UNITED STATES PATENT AND TRADEMARK OFFICE

Office Action Summary	Application No. 10/663,638	Applicant(s) BAKOS ET AL.	
	Examiner Ben Lewis	Art Unit 1795

Detailed Action

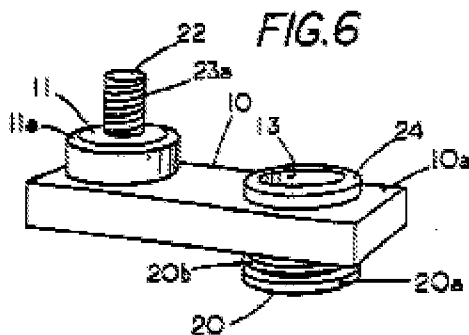
With respect to washer portion including radial projections extending there from, Whitney teaches an integral washer 11 as seen in figure 1 which includes projection 12, and also wherein the washer is regarded as having semi-circular projections below the head flats as seen in figure 1. It would have been obvious to one of ordinary skill in the art at the time the invention was made to provide a washer with the bolt head of Ratte et al. as modified by Williamson et al, in view of the teaching of Whitney, the motivation being to strengthen the seal of the bolt head of Ratte et al. as modified by Williamson et al.

With respect to claims 23, 32 and 35, claims 23, 32 and 35 are product by process claims. The insert molding of the bolt as molten lead, does not further limit the

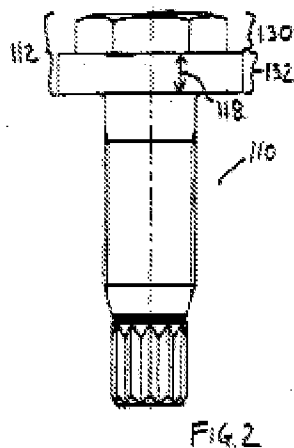
Ratte et al do not specifically teach a bolt with a tapered sealing portion and the shank portion has a larger diameter than a second end of said sealing portion that is connected to said thread portion. However, Williamson teach a transversely hydraulic coupling with lipped port wherein Collar **430** has external tapered surfaces **431** and **432** which sealingly engage body **405** and port **401'**, respectively “larger shank diameter and smaller sealing portion diameter”. External tapered surface **431** extends into body **405** to engage internal tapered surface **406**. Also, external tapered surface **432** extends into port **401'** to engage internal tapered surface **413** (Col 9 lines 64-67).
